LINCOLN STREET IMPROVEMENT PROJECT  
ADDENDUM #1

CITY OF LANDER  
**LINCOLN STREET WATER REPAIR  
STREET RECONSTRUCTION PROJECT  
TYPICAL SECTIONS**

PROJECT NO.: 17063

REV.: **ADDENDUM #1 - 03/18/24**

**ROADWAY TYPICAL SECTION - (LINCOLN STREET)**

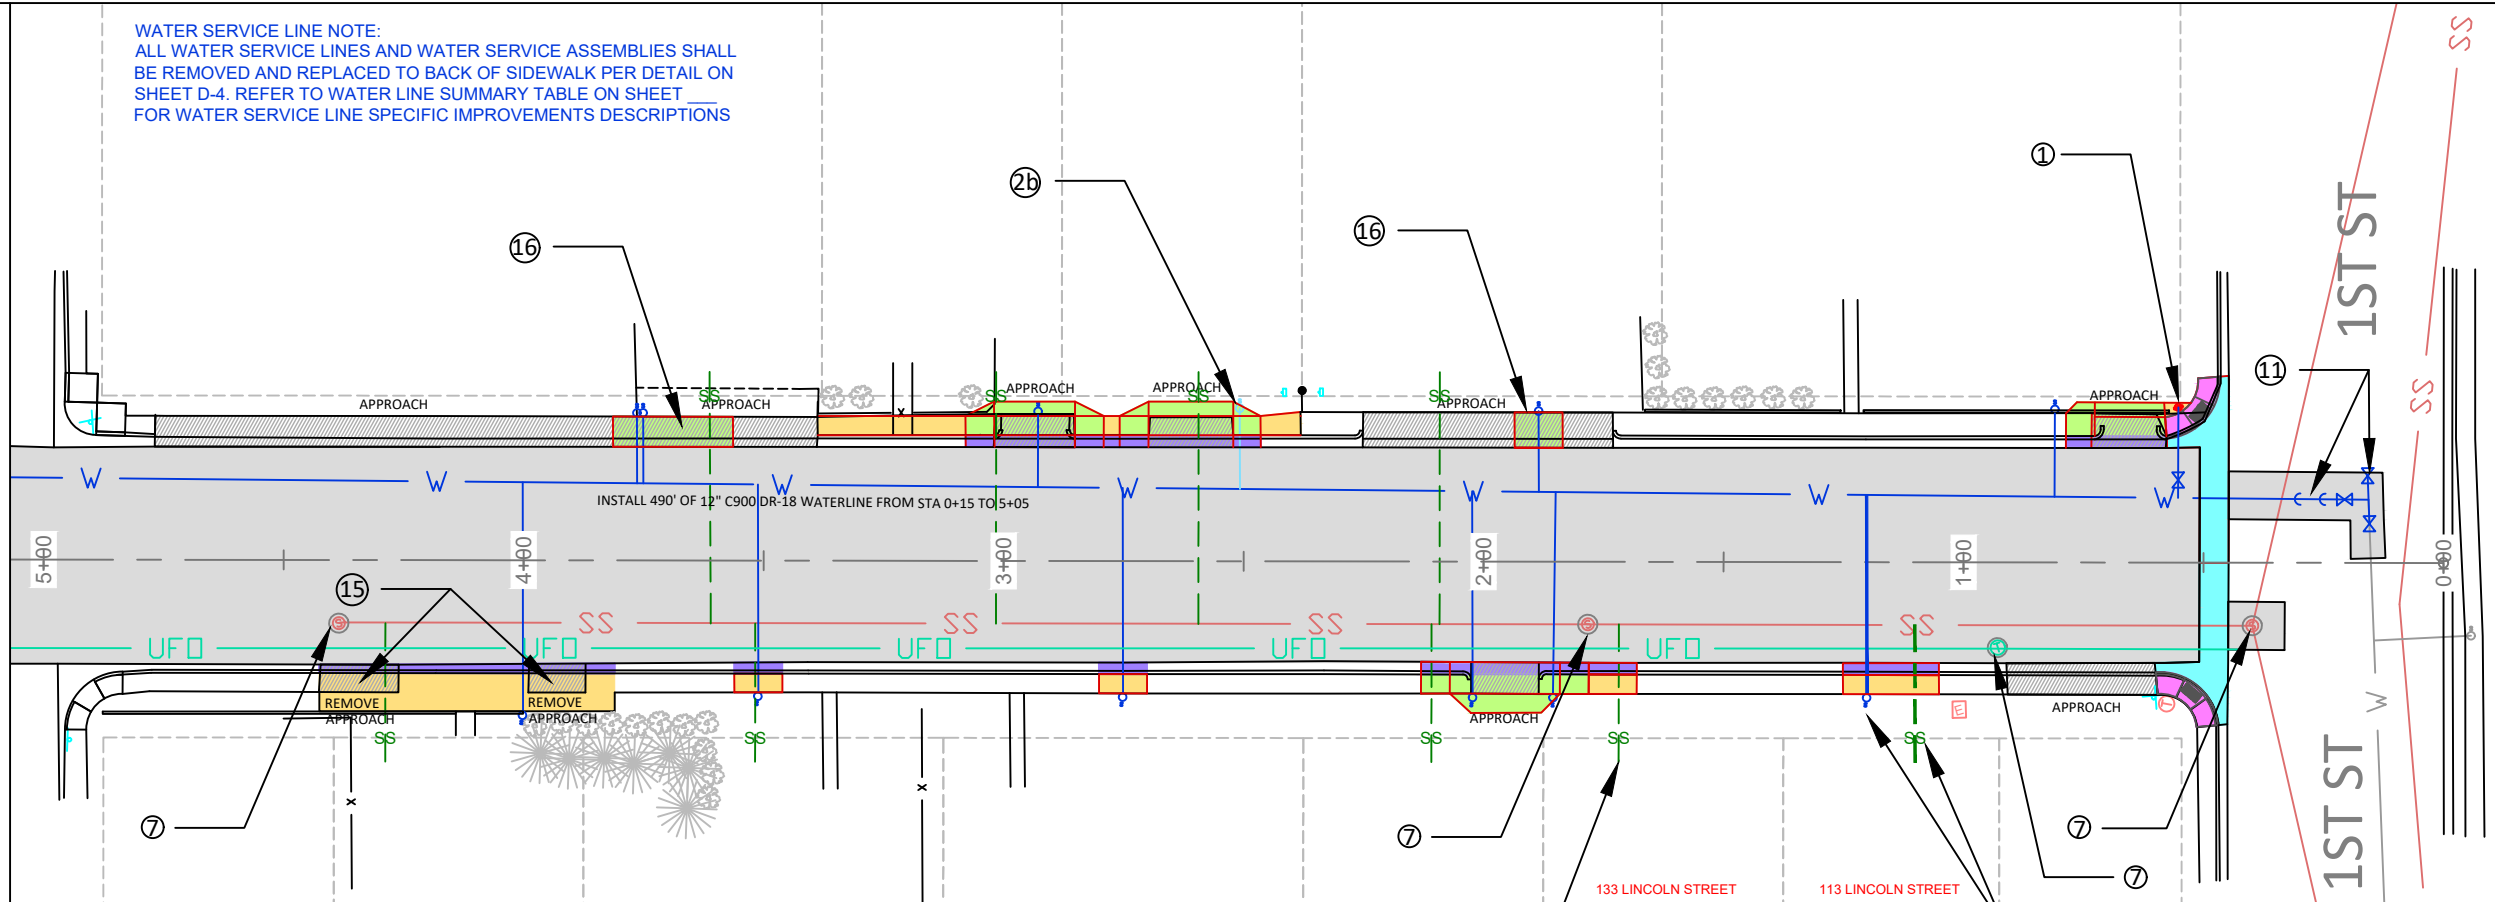
- a) See attached updated Bid Schedule.
- b) See added specification Note 2 on "Roadway Typical Section" Detail Sheet 2.
- c) Add the following paragraphs to Specification 01 1500:

- a) Replace Sheet 2 – Detail "Roadway Typical Section" – revisions reflect added Bid Items 8" Grade "W" Base Course and Geotextile Separation Fabric, and other edited notes to clarify typical work parameters

1. THE CONTRACTOR(S) OR SUBCONTRACTOR(S) SHALL SUBMIT MIX DESIGNS FOR CRUSHED BASE, PORTLAND CEMENT CONCRETE PAVEMENT, AND HOT PLANT MIX BITUMINOUS PAVEMENT 2 WEEKS (10 WORKING DAYS) PRIOR TO START OF CONSTRUCTION TO ENGINEER FOR ACCEPTANCE.
2. SHALL SATISFY WYDOT SPECIFICATION SECTION 805, APPARENT OPENING SIZE OF 40-100mm (TABLE 805.2-1) MIRAFI 160N OR SIMILAR, INSTALL PER MANUFACTURER'S REQUIREMENTS. INSTALL FULL WIDTH OF BASE AND ASPHALT, AND FABRIC SHALL SPAN THE UTILITY TRENCH.

PROJECT NO.: **17063**  
DRAWN BY: **JPL**  
REVIEWED BY: **SV**  
SHEET NO. **P-1**

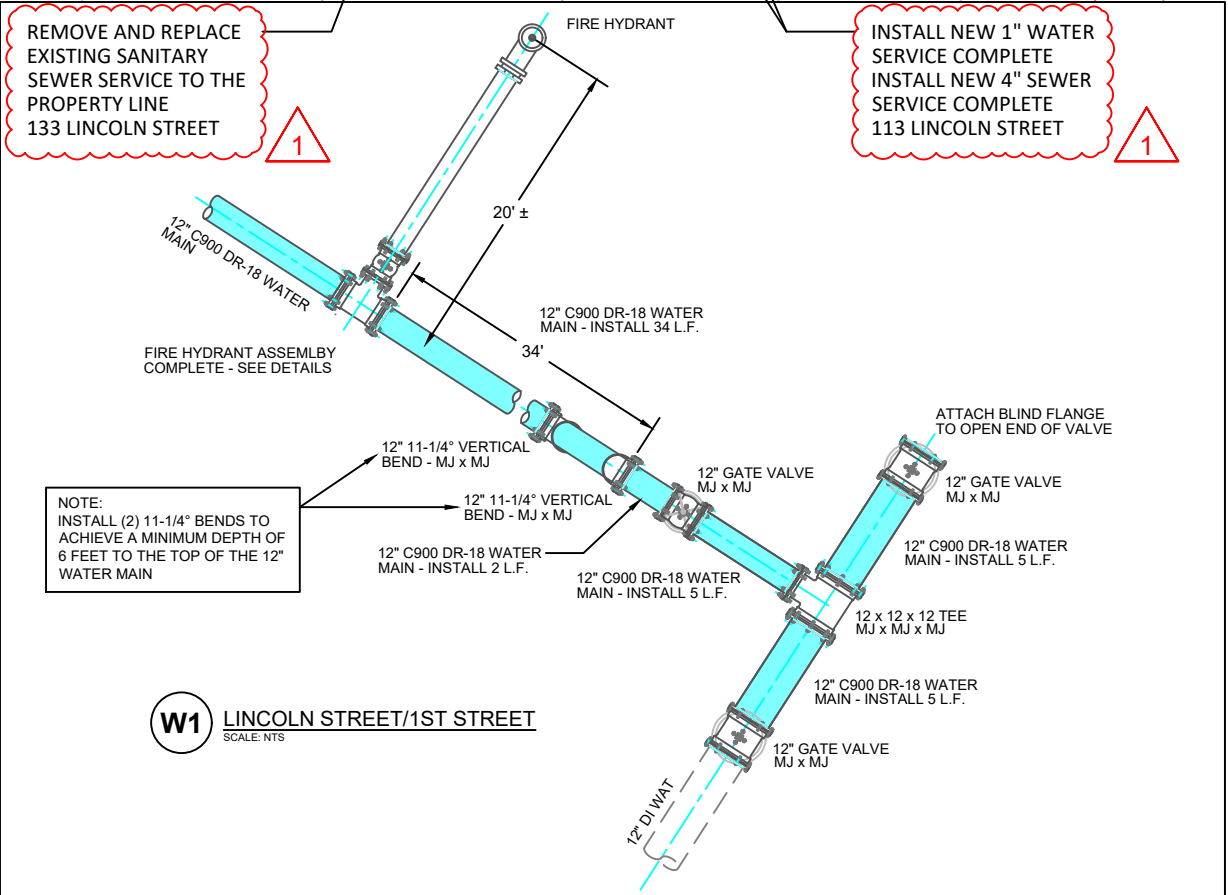
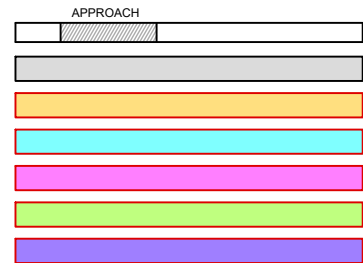
- b) Replace Sheets 3A, 3B, 3C, and 3D – work item Summary Tables were revised to match updated Bid Schedule quantities
- c) Replace Sheet P-1 – revisions reflect added replacement of sewer service to lot 113 (approx. STA 1+70, south side) and associated replacement of sidewalk, curb & gutter
- d) Replace Sheet C-101 – revisions reflect added replacement of sewer service to lot 113 (approx. STA 1+70, south side) and added callout note D
